## Addendum No. 4

Date: 05-20-2024

Project Name: NECSD – New CTE Building

CSArch Project No. 108-2303

CTE  
A309

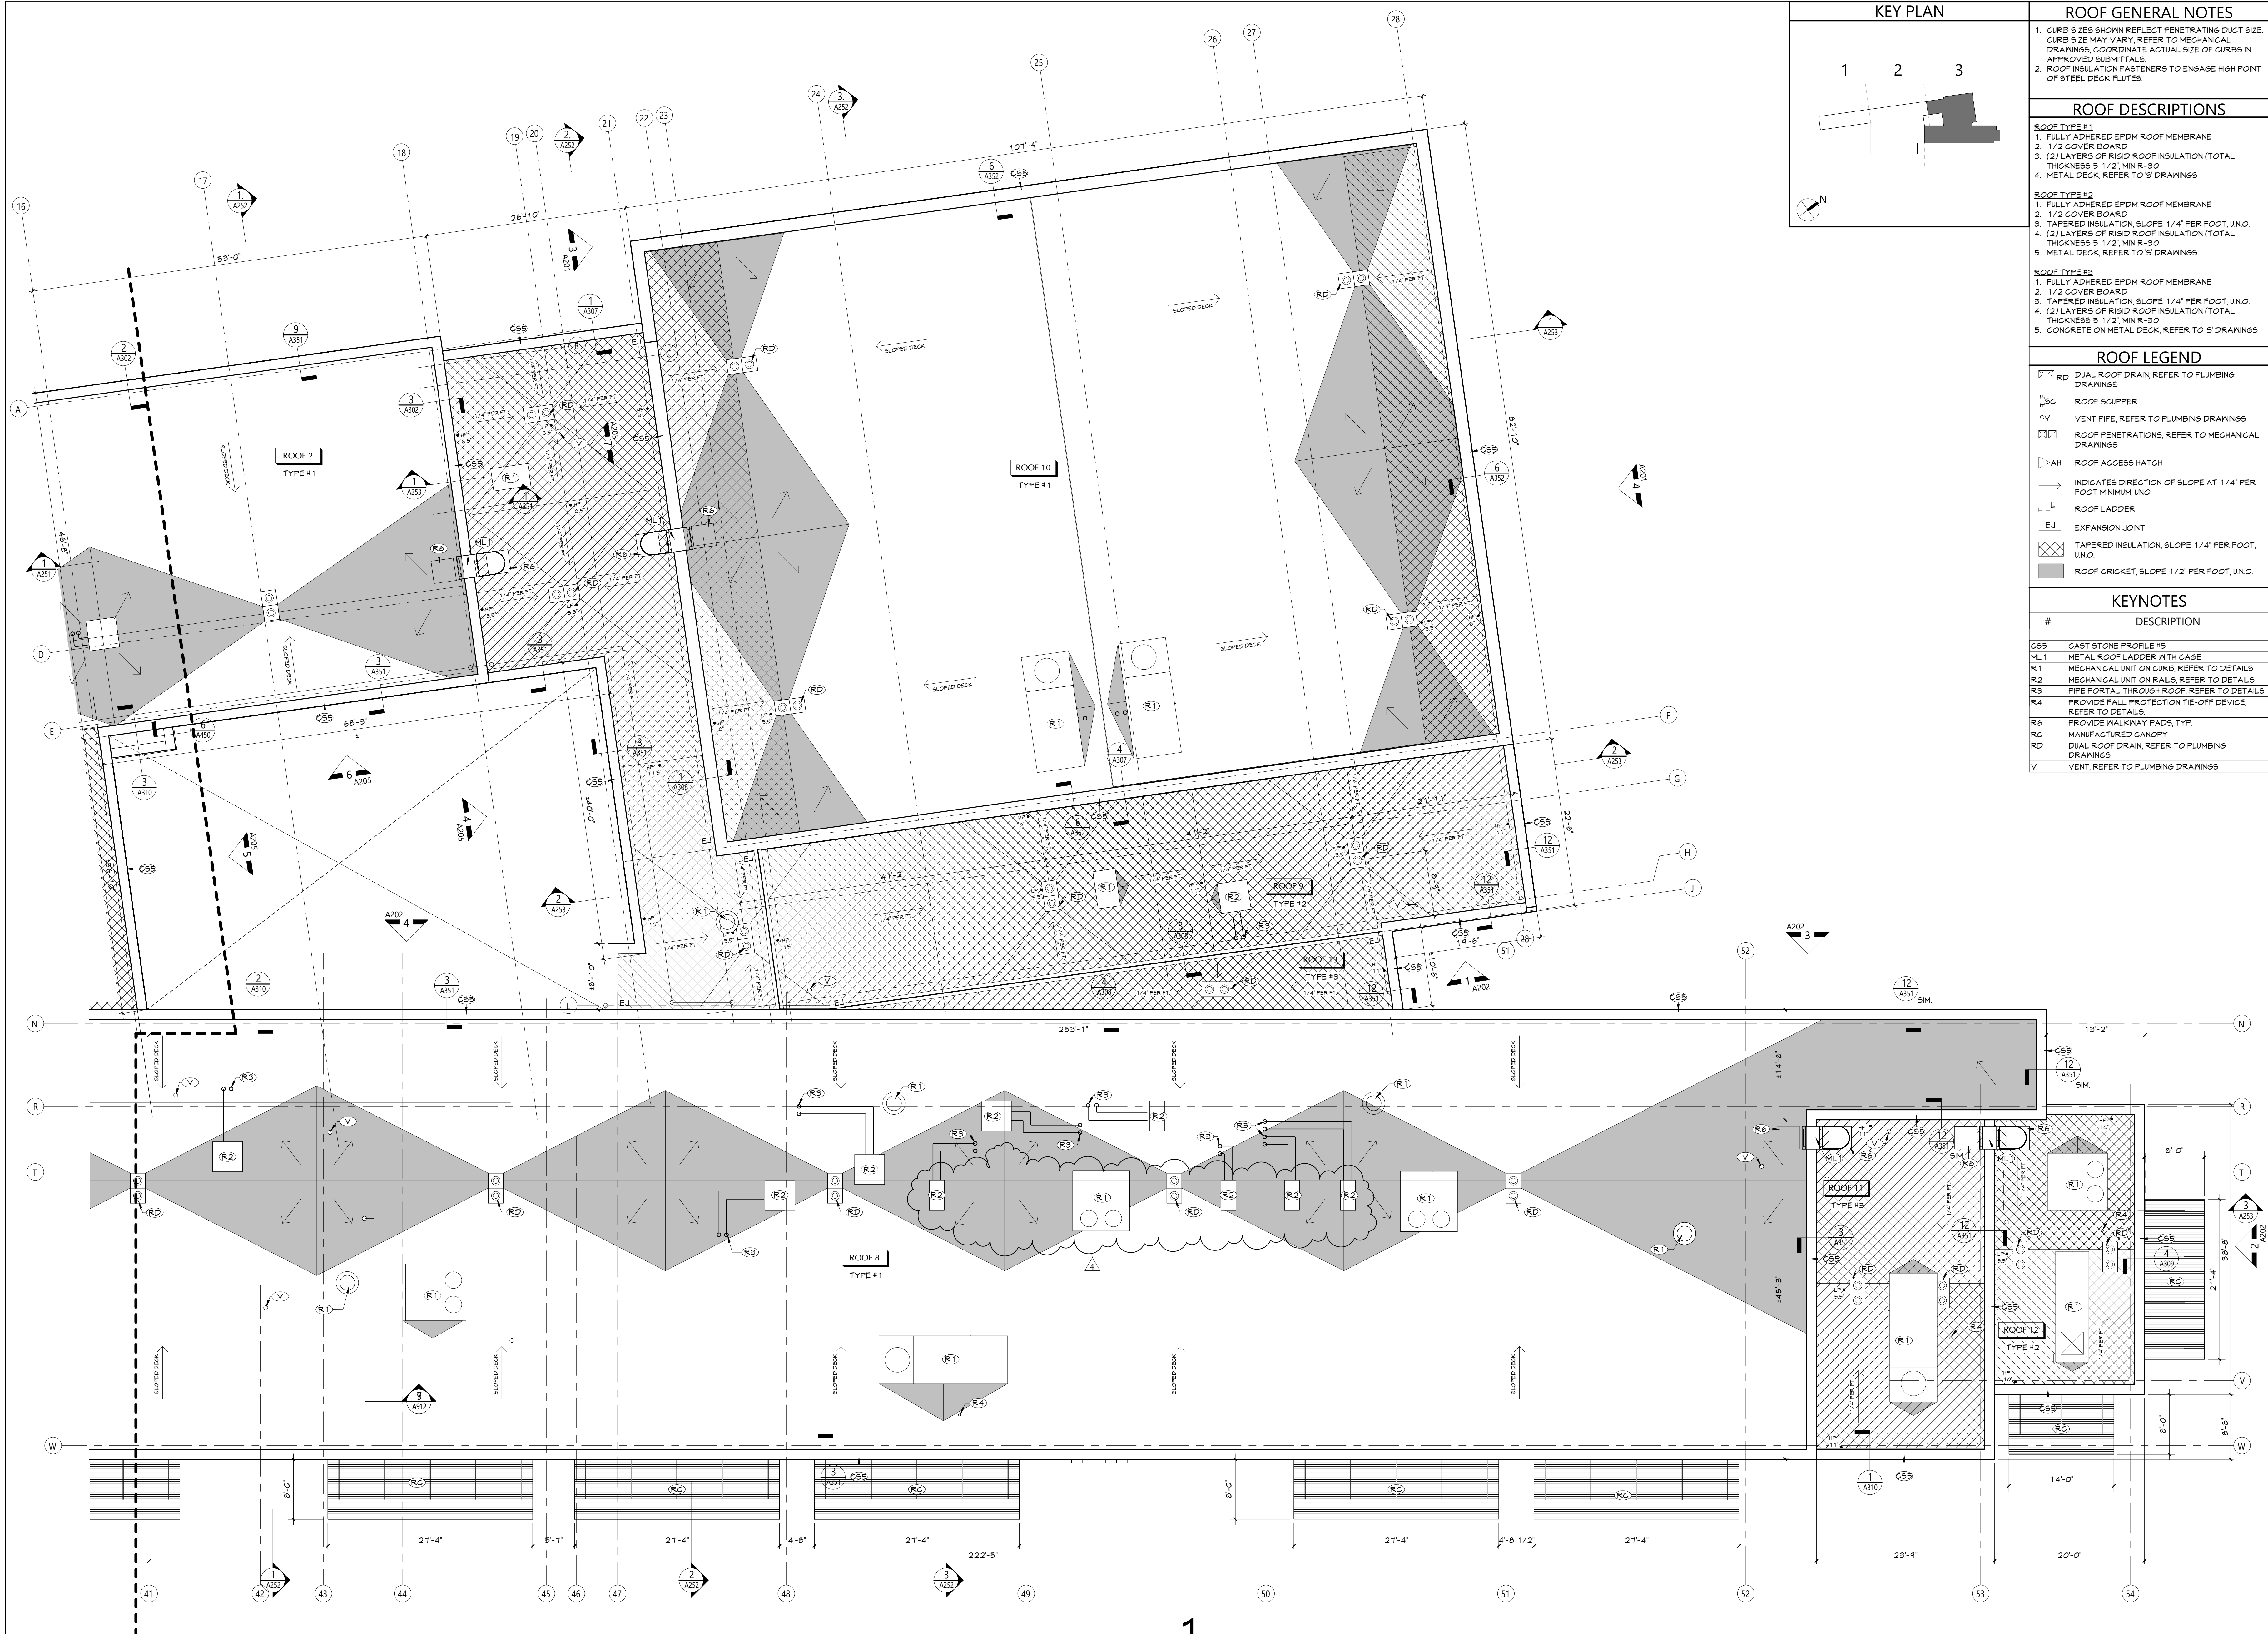
117	A	Wall Construction	Area 3 dr. A113 referring to wall section A309/3. Detail 3 / A309 showing CMU wall on 2nd floor, however wall construction description calls for different. Please clarify.	5/14/2024	Worth Construction Co., Inc.	Revised as part of addendum #4.	Yes	A309		Add #4
118	A	Casework	Casework detail 1 & 2 on Dr. A651, please explain what rooms this details should be use for.	5/14/2024	Worth Construction Co., Inc.	Details 1 & 2 on drawing A651 are typical details for plastic laminate casework. Refer to interior elevations for locations.	No			
119	A	Casework	Dr.123 no details shown for Rm. #224. Is the case work same kind as for Rm. #232? Please confirm.	5/14/2024	Worth Construction Co., Inc.	Revised as part of addendum #4.	Yes	A123		Add #4
120	G	Contract Award	Date Contract to be Awarded	5/14/2024	Joseph Lombardo Plumbing, Heating & Cooling, Inc.	Refer to addendum #2 for updated milestone schedule, specification section 003113.01. The anticipated award date is 6/18/2024 and the anticipated notice to proceed date is 6/19/2024.	No

1 ENLARGED FLOOR PLAN - COSMETOLOGY  
A604 1/4" = 1'-0"

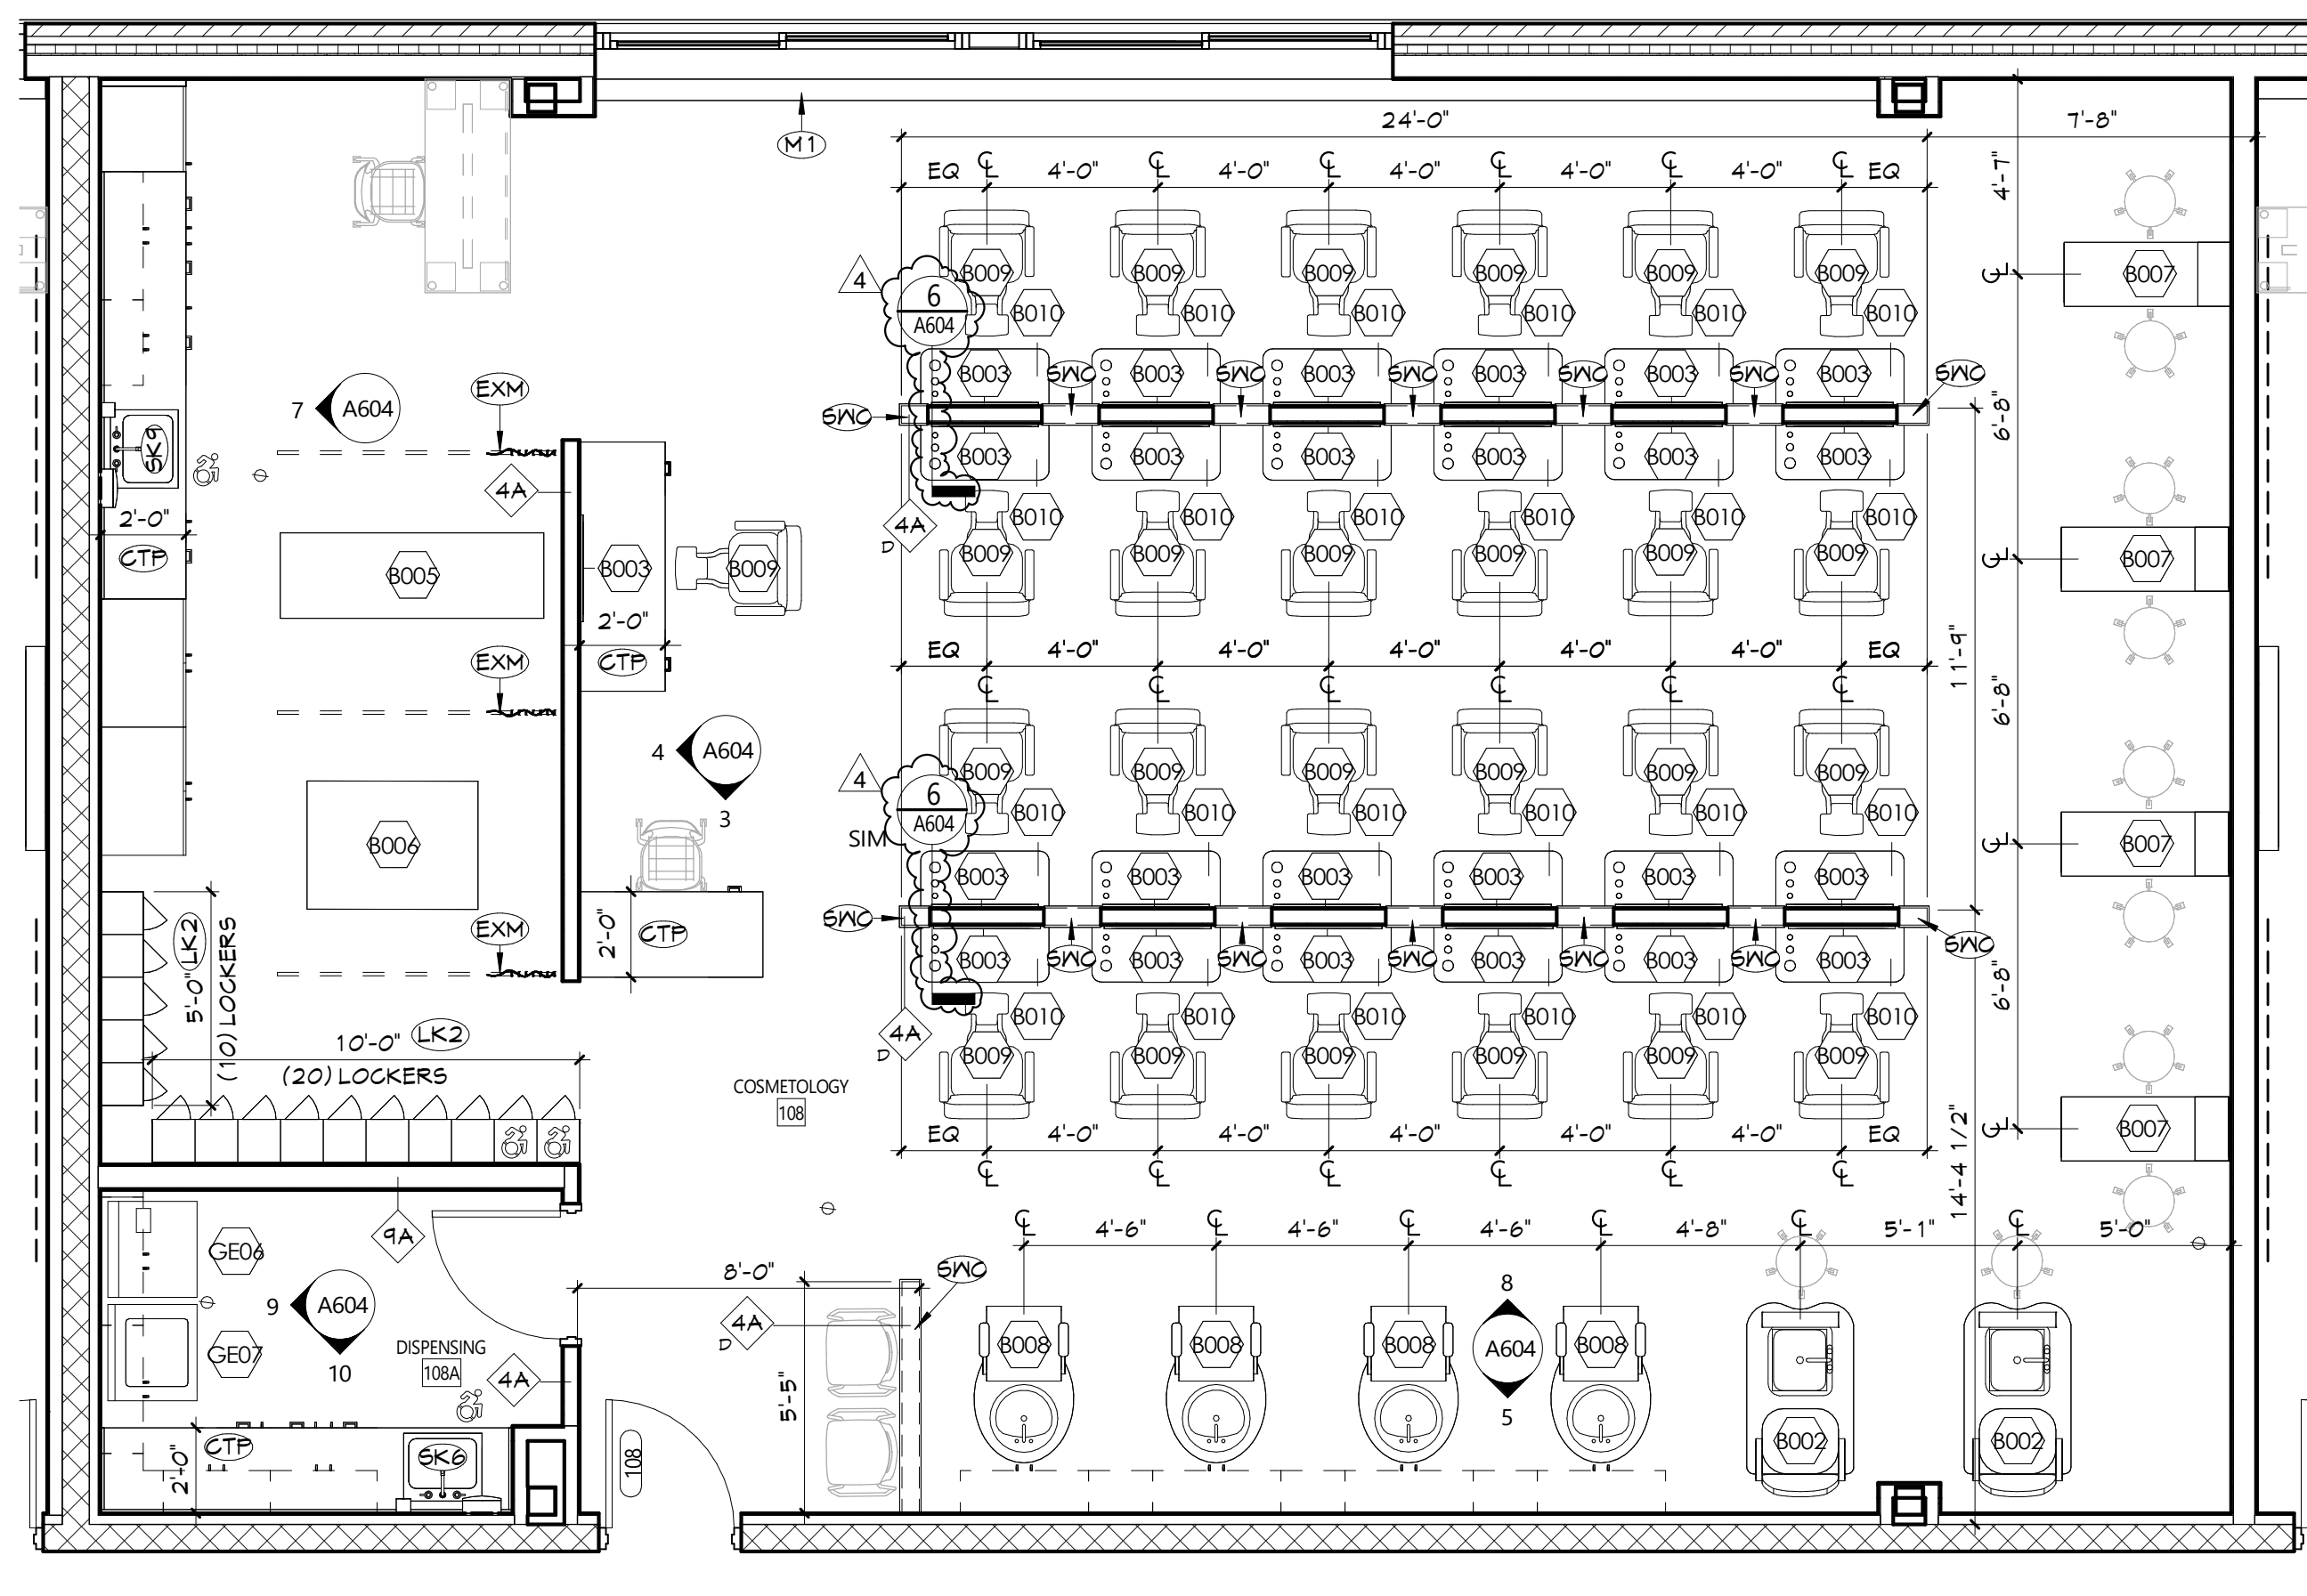
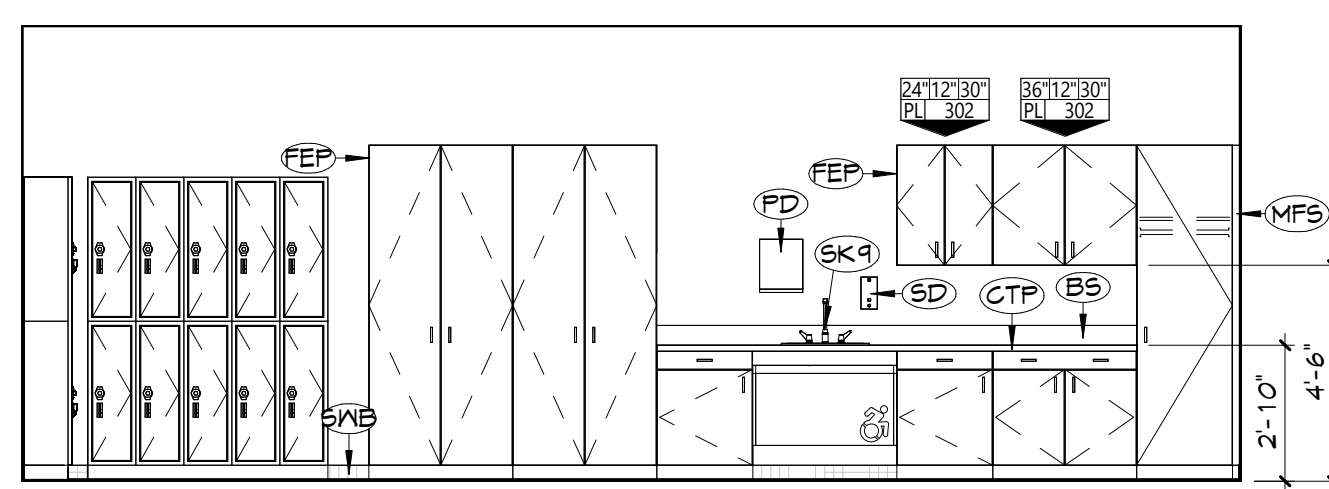
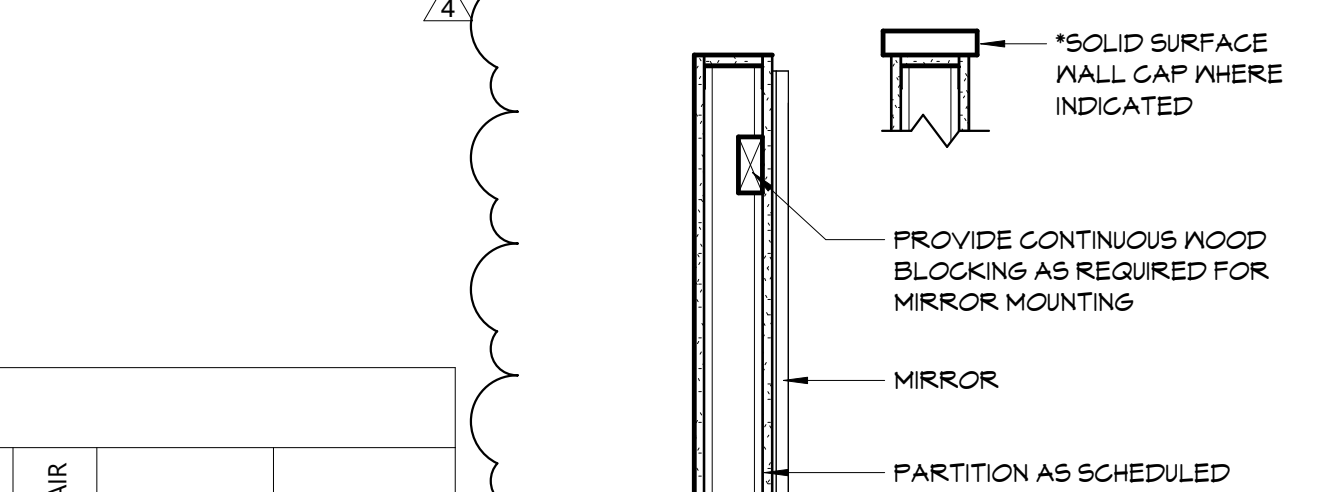
106	A	Gypsum Board	Spec 092116-2.3-B-3a states MR Gypsum Board throughout, however sheet A701, Note#8 goes into detail stating Type 'X' gypsum board unless listed below. Is the intent to have Type 'X-MR' gypsum board thru-out?	5/13/2024	Pike Construction Services, Inc.	Type 'X-MR' gypsum board thru-out. Revised as part of addendum #4.	Yes	A701, A702		
107	A	Batt Insulation	Is batt insulation in new metal framing acceptable? There is no mention of it in specifications.	5/13/2024	Pike Construction Services, Inc.	Bid as specified.  Spray foam insulation shall be used in exterior metal framed walls as per specification section 072119.  Acoustic insulation to be used at interior metal framed partitions as per specification section 092216, 2.1, F., 8.	No			
108	A	A604	Per detail 11/A604 there is a half wall at the section cut thru indicating detail 6/A604. Can a detail thru the 'B003' mirror area please be provided. (How are the mirrors attached/hung? Is there a wall behind them?)	5/13/2024	Pike Construction Services, Inc.	Revised as part of addendum #4.	Yes	A604		Add #4
